Replacement of T2374 with T2372

Pagid aims to streamline the designation from T2374 to T2372.

T2374

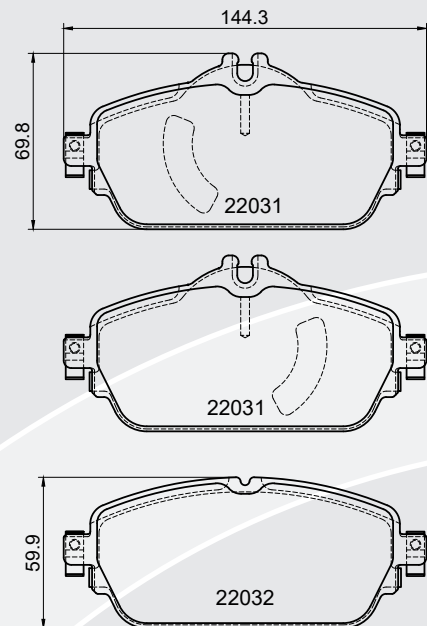
Given the identical outer dimensions of the brake pads we can ensure seamless assembly and operation. The parts are differing by a cut out in the shim for T2372 while the adhesive foil for the outer pads will disappear.
